SURVEY OF:

A PORTION OF THE WEST 1/2 OF SEC. 5, T.1N., R.11E., W.M., HOOD RIVER COUNTY, OREGON

Re: Survey in Section 5 T1N, R11EWM

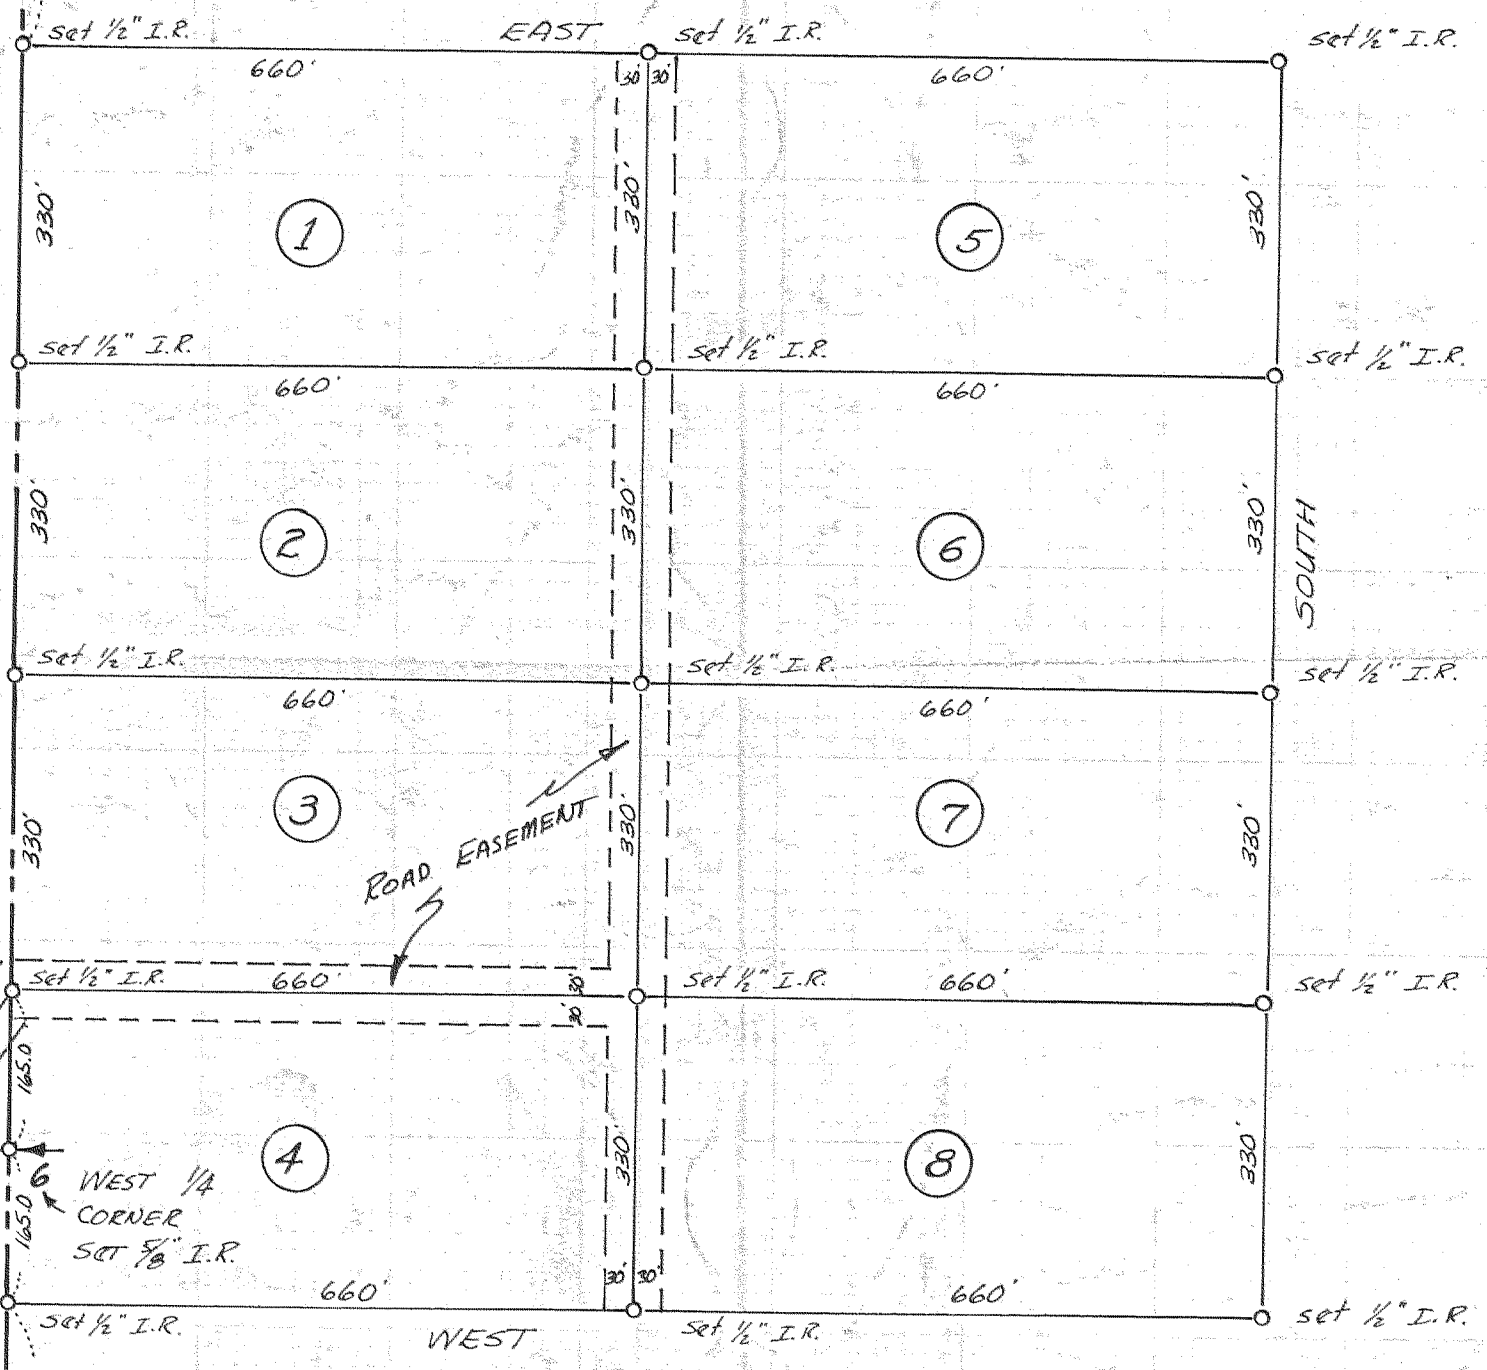
We are particularly interested in the above survey in that the East boundary shown on your plat would be common to County Forest lands. As it would appear the Section was not properly subdivided, we would, of course, be very hesitant about accepting this as the boundary if a survey has not been run to establish this 1/16<sup>th</sup> line.

In addition to questioning this East line, we also question the placement of the West 1/4 corner of Section 5. Our records indicate an original corner available here. Was a search made for this corner? If so, and it was not found, our records indicate an original G.L.O. distance on this line of 76.26 chains or 5,033.16 feet against your distance of 5,055.64 feet. Using these distances and proportioning for a North tier Section, we come up with a location for the 1/4 corner being 2,651.80 feet North of the corner to Sections 5, 6, 7, & 8 opposed to the 2,683.80 feet shown on your plat.

We found the Northwest and Southwest corners of Section 5 only. An unsuccessful attempt to find the  $\frac{1}{4}$  corner between sections 5 and 6 was made. The survey was based on a survey of Section 6 filed in your office, December 20, 1910 by the County Surveyor. The distance from the southwest corner of Section 5 to the  $\frac{1}{4}$  corner between 5 and 6 was shown on this old survey and held on ours.

All other points set are for line only and do not indicate any section subdivision.
